[Docket No. 93-CE-61-AD; Amendment 39-9386; AD 95-20-07]

Airworthiness Directives; The New Piper Aircraft, Inc. (Formerly Piper Aircraft Corporation) PA24, PA28R, PA30, PA32R, PA34, and PA39 Series Airplanes**AGENCY:** Federal Aviation Administration, DOT.**ACTION:** Final rule.

Figure 1

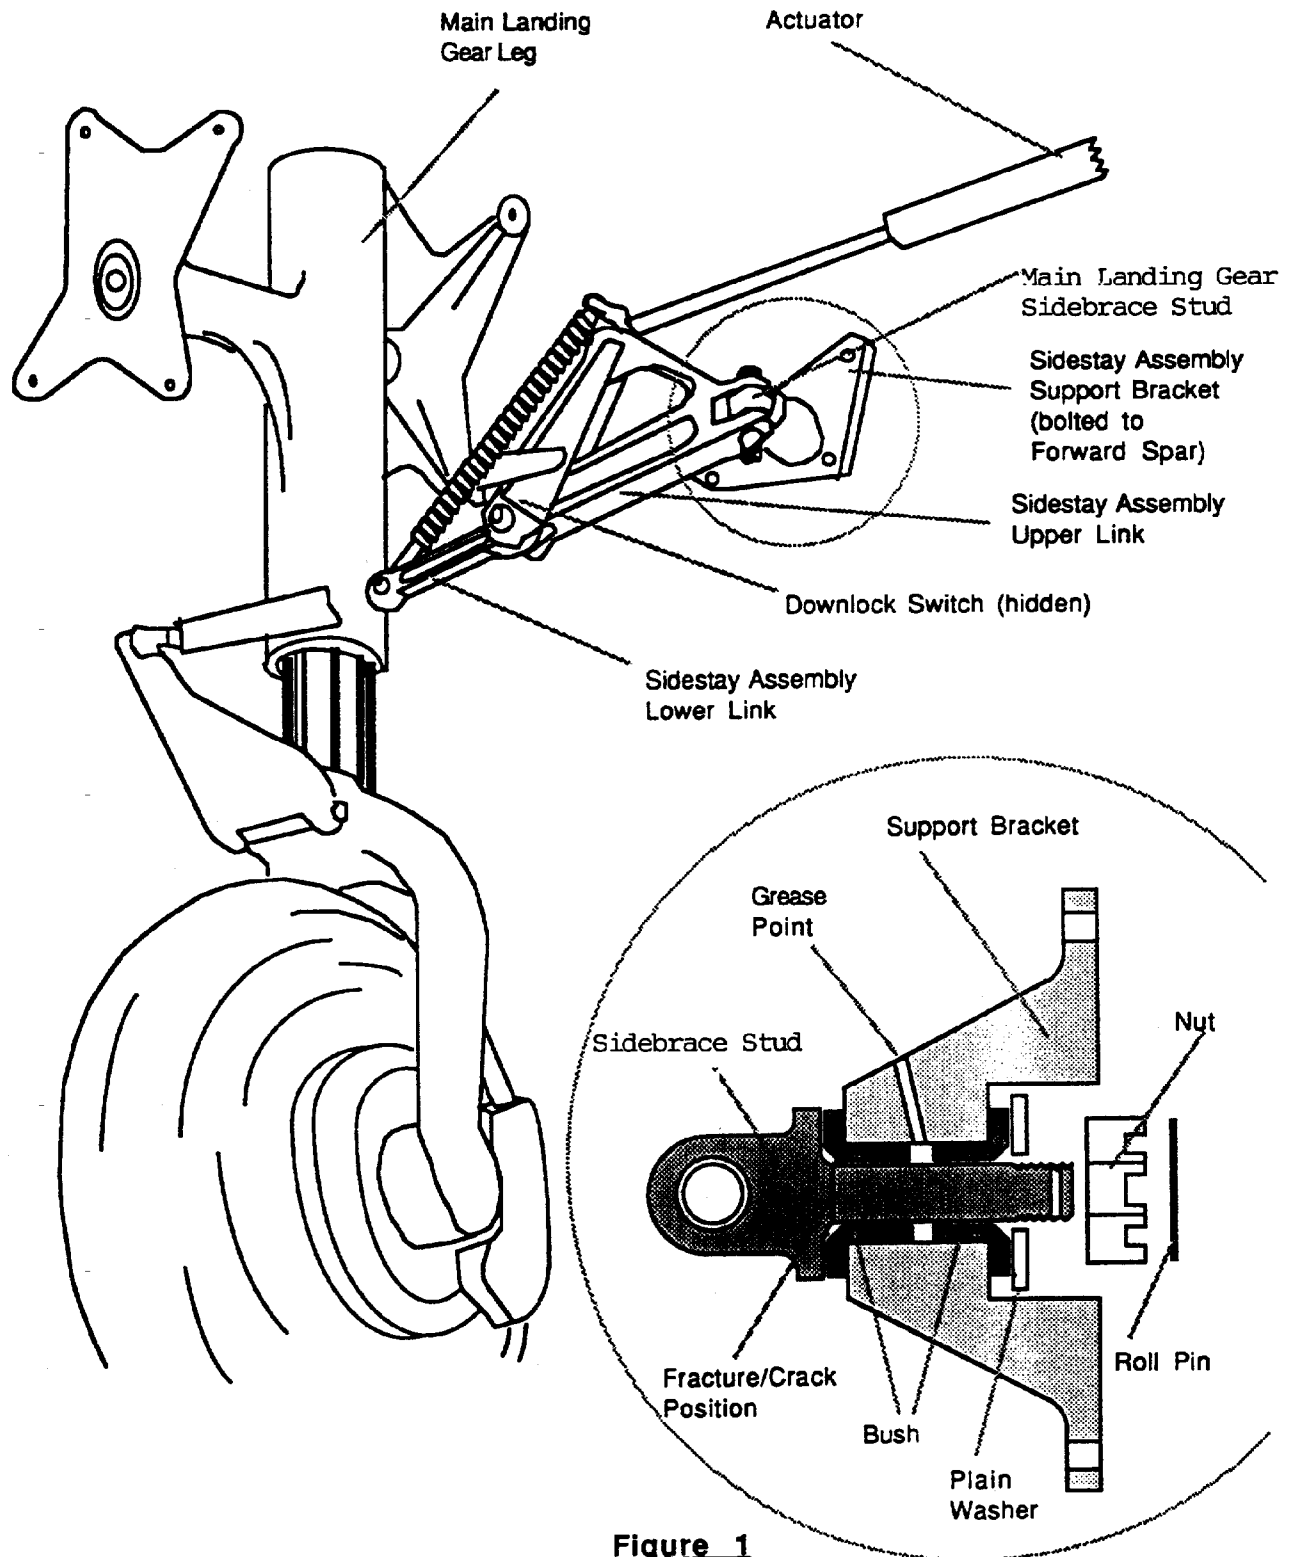
One commenter requests that the FAA include a figure that identifies the area requiring non-destructive inspection. The FAA has added Figure 1 to the AD to comply with this commenter's request.

(a) Remove both the left and right main gear side brace studs from the airplane in accordance with the instructions contained in the Landing Gear section of the maintenance manual, and inspect each main gear side brace stud for cracks, using Type I (fluorescent) liquid penetrant or magnetic particle inspection methods. Inspections must be accomplished by a facility approved by the FAA to accomplish the applicable inspection method. Figure 1 of this AD depicts the area where the sidebrace stud is to be inspected.

Note: This figure is provided to depict the area of the sidebrace stud to be inspected. This is not intended to represent the configuration of all models affected.
